Service Bulletin

Conversion of aircraft from CASA certificated FAR23 Amendment 45/48 status to CASA certificated FAR23 Amendment 54 status.

All GA8 aircraft serial numbers GA8-00-004 through GA8-03-025.

Document: Service Bulletin SB-GA8-2003-04

Figure 2-1 – Aft luggage bin installation

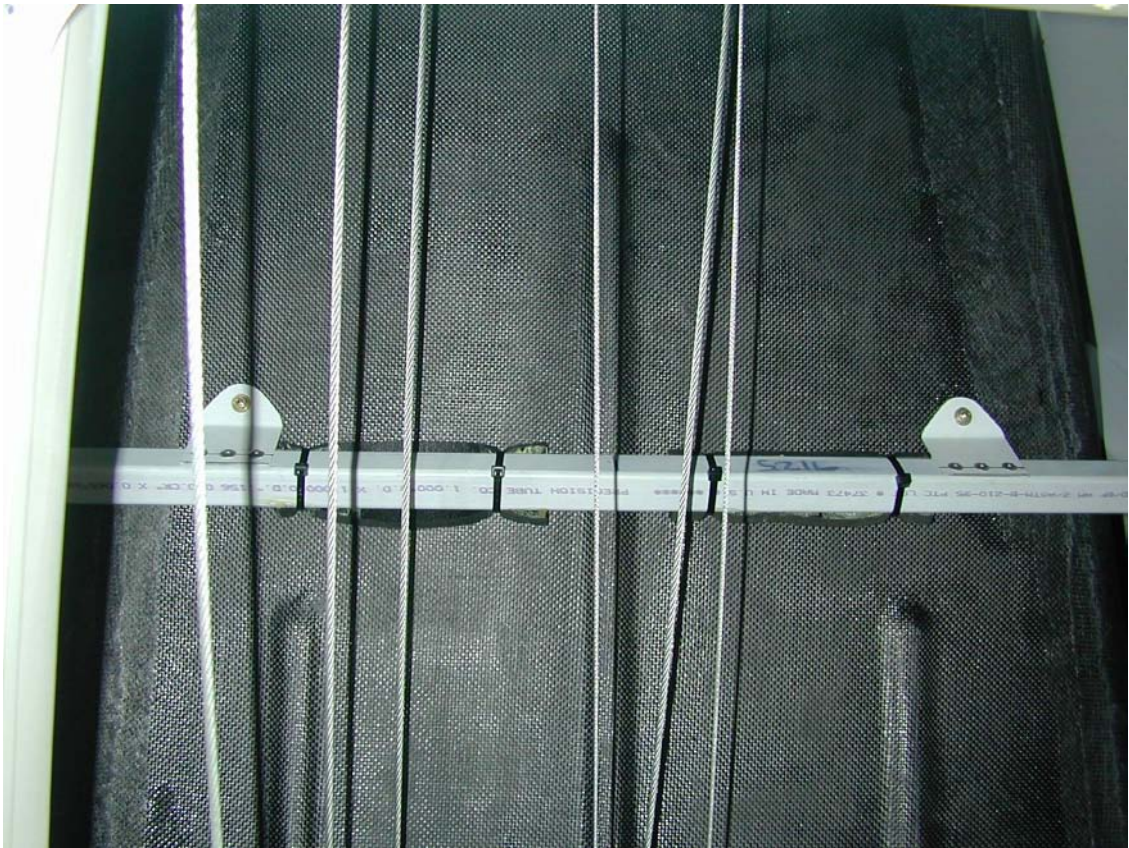
1. Remove the existing aft luggage bin by removing the 24 S1022Z6-8 countersunk screws attaching the bin to the aft bulkhead, and the two AN-4 bolts attaching the bin to the cross member. Refer to Figure 2-1.
2. Using the existing bin as a guide, drill off holes in the flange of the new aft luggage bin (P/N GA8-255012-13).
3. Insert the new bin and attach to the aft bulkhead using hardware removed in step 1.
4. Drill through the brackets on the cross member and attach using the AN-4 bolts removed in step 1. The cross member is accessed through the bottom skin inspection panel. Refer to Figure 2-2.

Figure 5-1 - Pitot heat installation (overhead panel)

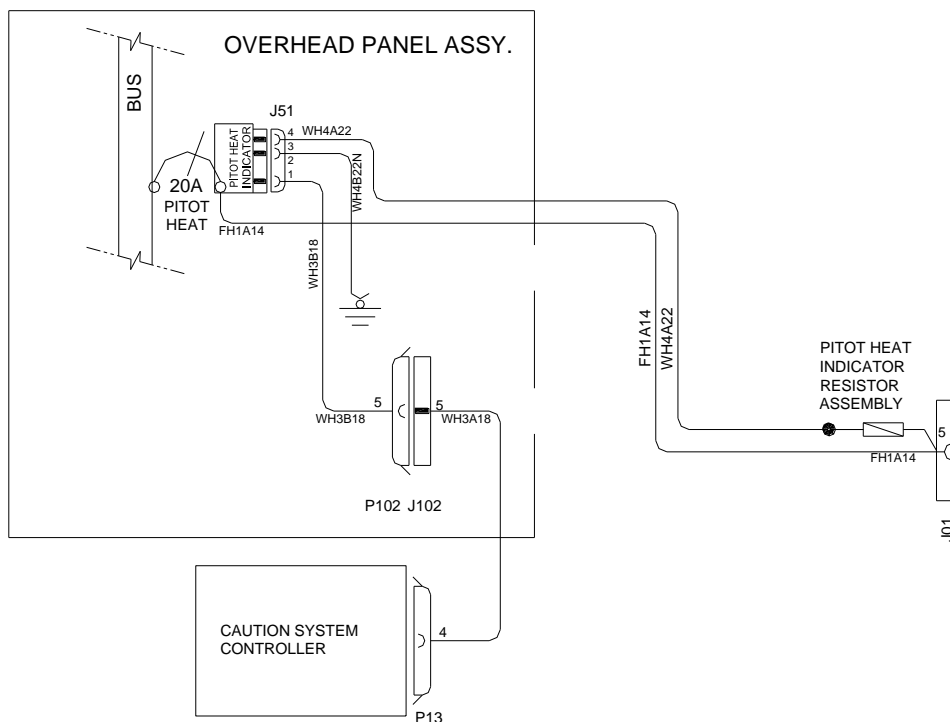
1. Remove pilot's seat and floor carpet. Remove battery box cover. Disconnect battery. Disarm the alternator excitation system if already installed.
2. Install circuit board (P/N GA8-315017-17) and wire FH1A14 to output terminal of the Pitot Heat Switch/Breaker in the overhead switch panel. Refer to Figure 5-1.
3. Install pitot heat indicator resistor assembly on the pitot heat feed wire FH1A14 at pin 5 of socket J01 of the wing root junction block. Solder one end of wire WH4A22 to the resistor, and the other end to pin 4 of socket J51 at the overhead electrical panel. Install wire WH4B22N between pin 3 of socket J51 and a suitable earth. Install wire WH3B18 between pin 1 of socket J51 and pin 5 of plug P102, and wire WH3A18 between pin 5 of socket J102 and pin 4 of plug 13 of the caution system controller. Refer to Figure 5-1.

Figure 6-1 – Caution/warning light wiring schematic (instrument panel)

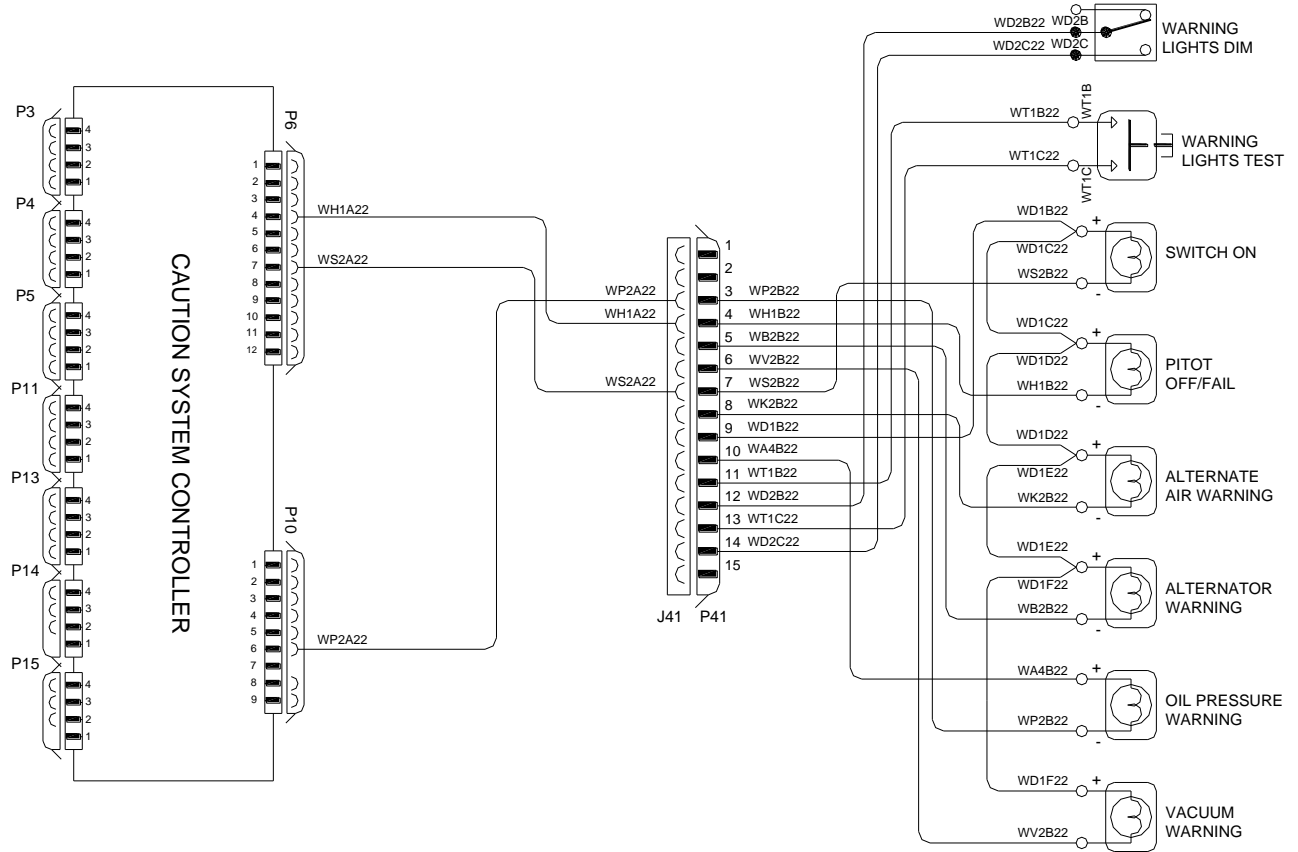
10. Install wire WH1A22 between pin 4 of plug P6 of the caution system controller and pin 4 of socket J41. Refer to Figure 6-1 for wiring schematic (Note – this wire may already be installed. If so disregard this step).
11. Install wire WH1B22 between pin 4 of plug P41 and the negative terminal of the "PITOT HEAT" light. Refer to Figure 6-1 for wiring schematic.

12. Install wire WS2A22 between pin 7 of plug P6 of the caution system controller and pin 7 of socket J41. Refer to Figure 6-1 for wiring schematic

13. Install wire WS2B22 between pin 7 of plug P41 and the negative terminal of "Switch On" light. Refer to Figure 6-1 for wiring schematic.
14. Install wire WP2A22 between pin 6 of plug P10 of the caution system controller and pin 3 of socket J41. Refer to Figure 6-1 for wiring schematic

15. Install wire WP2B22 between pin 3 of plug P41 and the negative terminal of "Oil" light. Refer to Figure 6-1 for wiring schematic.
16. Connect wire WA4B22 between pin 10 of plug P41 and the positive terminal of the oil pressure warning light. Refer to Figure 6-1 for wiring schematic.

17. Connect wires WD1B22 thru WD1F22 between the positive terminals of each light, except for the oil pressure warning light. Refer to Figure 6-1 for wiring schematic.

Figure 6-2 Oil pressure line modification

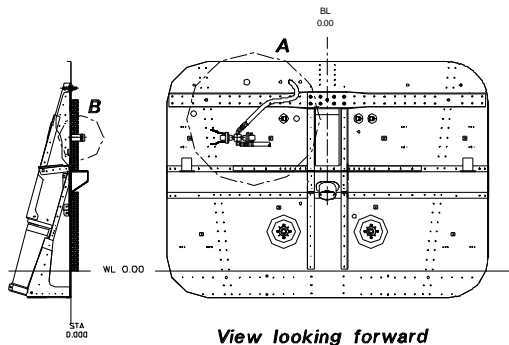
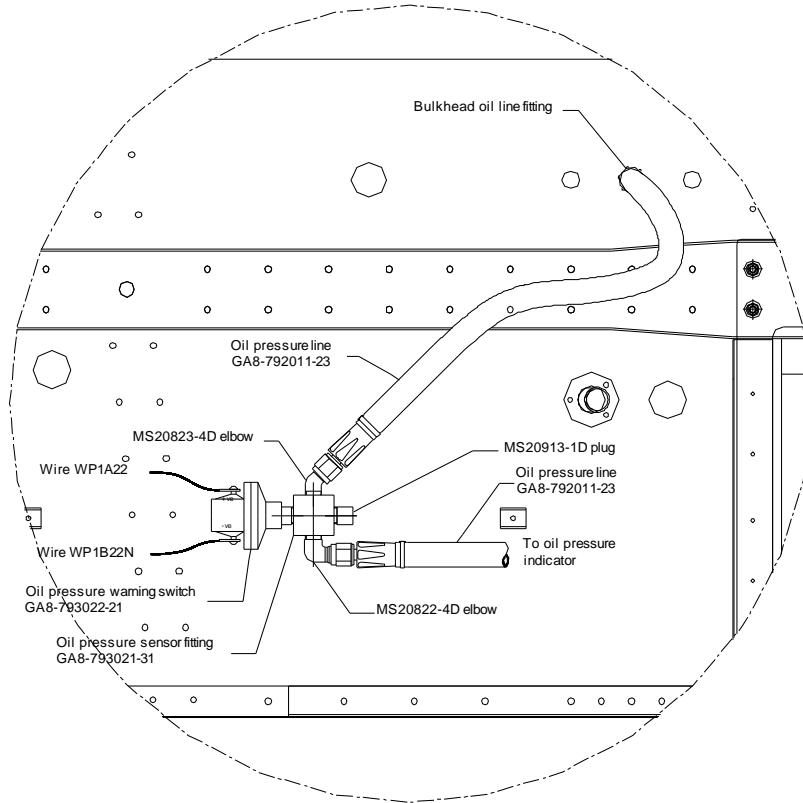
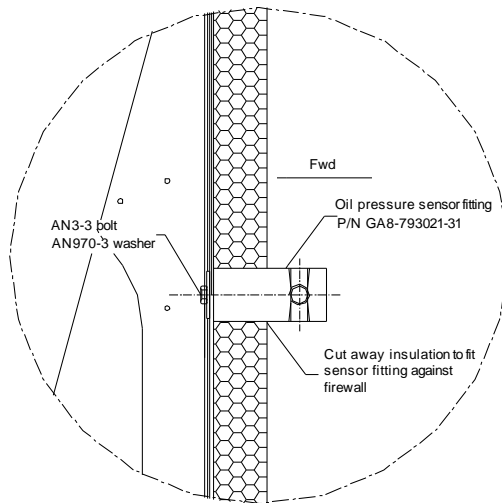
18. Drill a 0.189" diameter hole in the firewall 5.0" above the hot air duct and 9.5" from the left hand side cabin wall. Fit oil pressure sensor fitting (P/N GA8-793021-31) and attach using an AN3-3 bolt and AN9703-3 washer. Refer to Figure 6-2.
19. Connect oil pressure warning switch (P/N GA8-793022-21), MS20823-4D 45° elbow, MS20913-1D plug and MS20822-4D 90° elbow to the oil pressure sensor fitting. Refer to Figure 6-2.
20. Disconnect existing oil line between the oil pressure indicator on the instrument panel and the firewall fitting. Connect oil pressure line (P/N GA8-792011-23) between the firewall fitting and the MS20823 elbow. Connect oil pressure line (P/N GA8-792011-23) between the MS20822 elbow and the oil pressure indicator. Refer to Figure 6-2.

Instead of fitting new oil lines, the existing line may be modified by cutting in half and fitting Stratoflex 300-65 or Aeroquip 491-4 end connectors

Figure 6-3 – Oil pressure switch installation

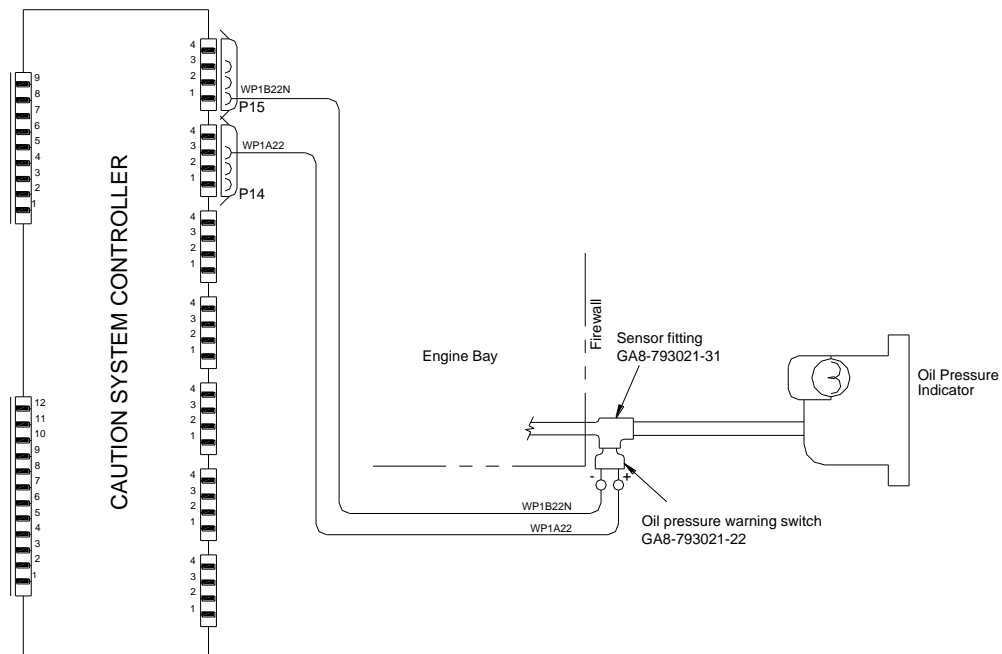
21. Install wire WP1A22 between the positive terminal of the oil pressure switch (GA8-793022-21) and pin 3 plug 14 of the caution system controller. Install wire WP1B22N between the negative terminal of the oil pressure switch and pin 1 of plug 15 of the caution system controller. Refer to Figure 6-3 for wiring schematic.

Figure 7-1 – Circuit breaker panel capacitor installation

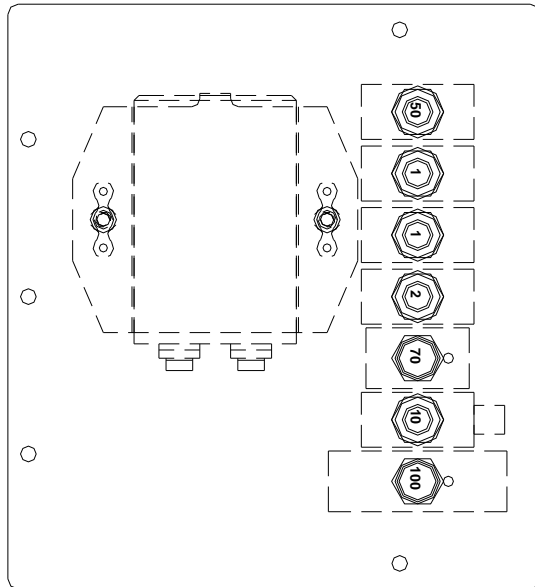
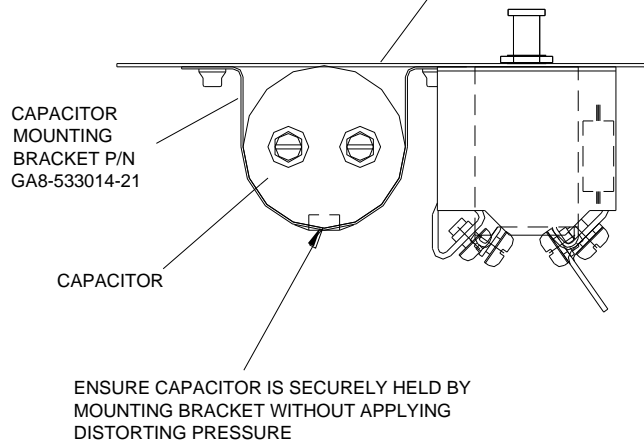
8. Attach capacitor and capacitor mounting bracket (P/N GA8-533014-21) to the new circuit breaker panel. Refer Figure 7-1. Refer to Section 8 **Alternator Excitation System Installation** for capacitor wiring details.

Figure 7-2 – Shunt and bus bar installation

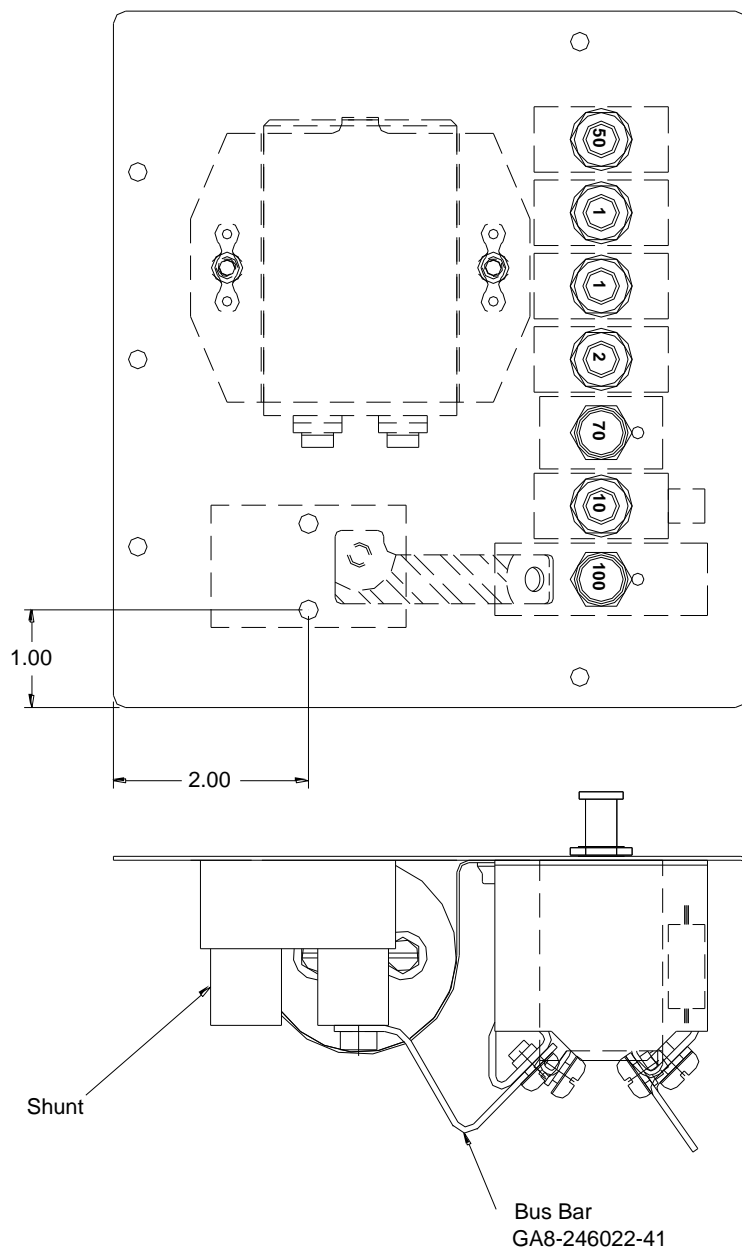
9. Attach the new ammeter shunt to the circuit breaker panel. Connect the shunt bus bar (P/N GA8-246022-41) between the shunt and 100A breaker. Refer to Figure 7-2.

Figure 7-3 – Solenoid box floor opening extension

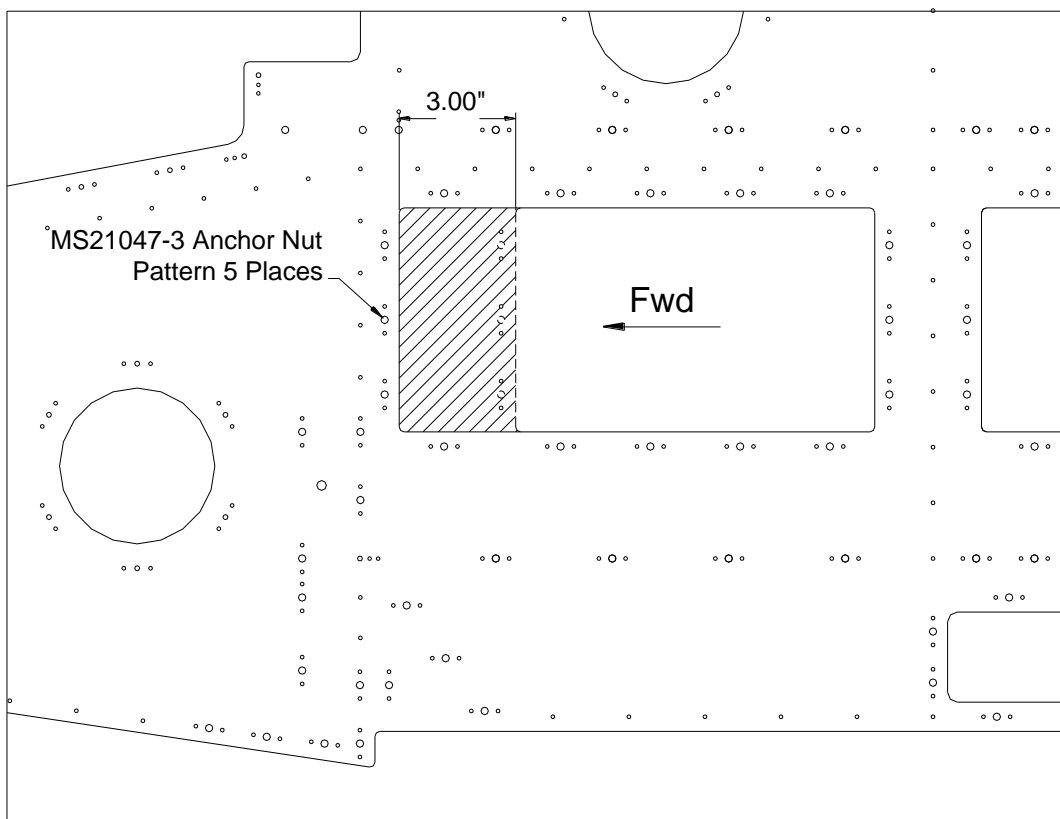
11. Extend the solenoid box floor opening by 3.0" as per Figure 7-3. Use the new elongated solenoid box (P/N GA8-533023-23) as a pattern to locate 5 additional anchor nut positions at the front of the extended opening. Rivet MS21047-3 anchor nuts to the floor using MS20426AD3-3 rivets.

Figure 7-4 – Solenoid box fit-out

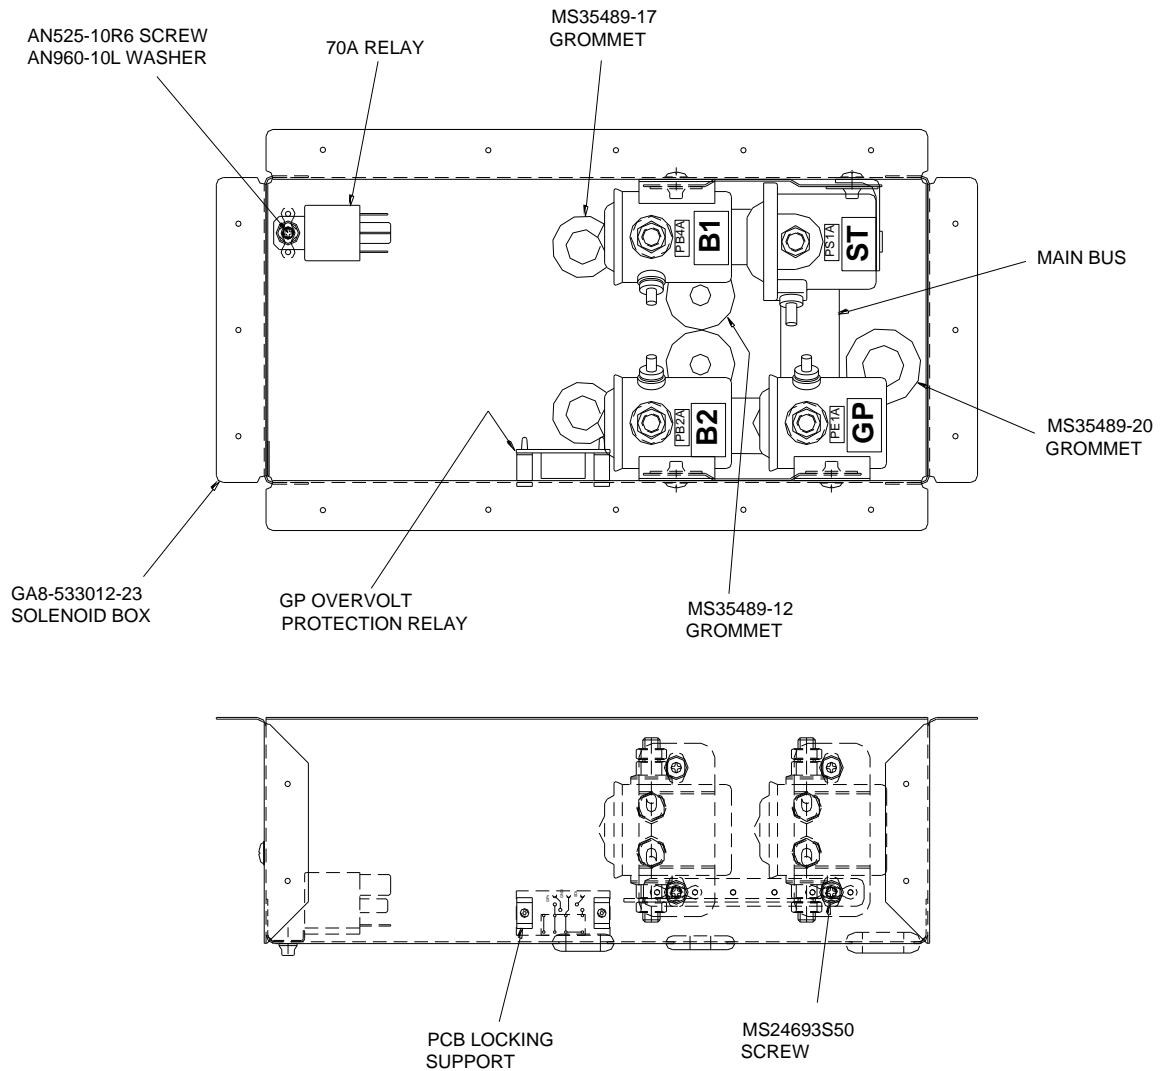
12. Fit all parts removed in step 6 into the new elongated solenoid box per Figure 7-4.
13. Install the new elongated solenoid box into the floor and secure using the MS24694S52 screws removed in step 10.
